BAGHDAD INTERNATIONAL AIRPORT  
POWER SYSTEM ENHANCEMENT  
BAGHDAD, IRAQ

SUSTAINMENT ASSESSMENT

**SIGIR PA-07-097**  
**APRIL 26, 2007**

**SUBJECT: Report on Baghdad International Airport Power System Enhancement, Baghdad, Iraq  
(Report Number SIGIR PA-07-097)**

**Site Photo 5. Cummins generator sets (Photo provided by USAID)**

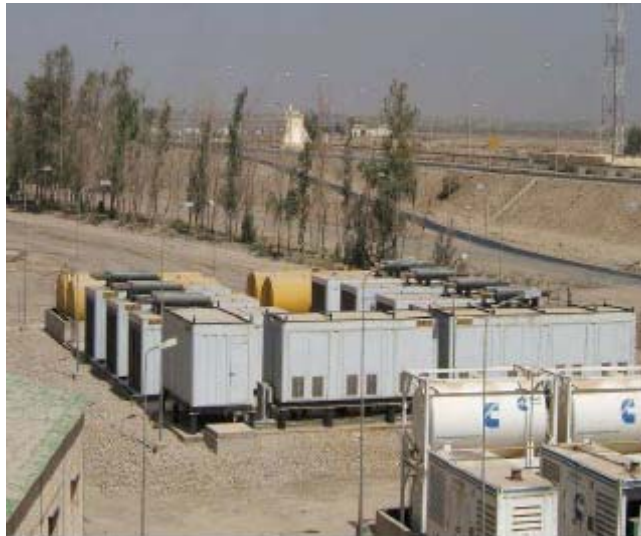
8. Page 5, site photo 5: The generators pictured are Caterpillar, not Cummins.
9. Page 9, first paragraph, fourth sentence: We recommend that the sentence which reads “However, the BIAP power plan management claimed that the commissioning and startup of the GE generators sets were not completed and were not accepted” be revised to read as follows: “During SIGIR’s March 3, 2007 site visit, the BIAP power plant manager indicated that commissioning and startup of the GE generators sets were not completed and that these generators were not accepted by the GOI. However, information presented by USAID verified that these generators were fully installed and commissioned at the project’s completion and were included in the package of 17 generators USAID turned over to the Government of Iraq under the project.”

8. **USAID Comments.** “Page 5, site photo 5: The generators pictured are Caterpillar, not Cummins.”

**SIGIR Response.** Site Photo 5 shows Cummins generators, not Caterpillars.
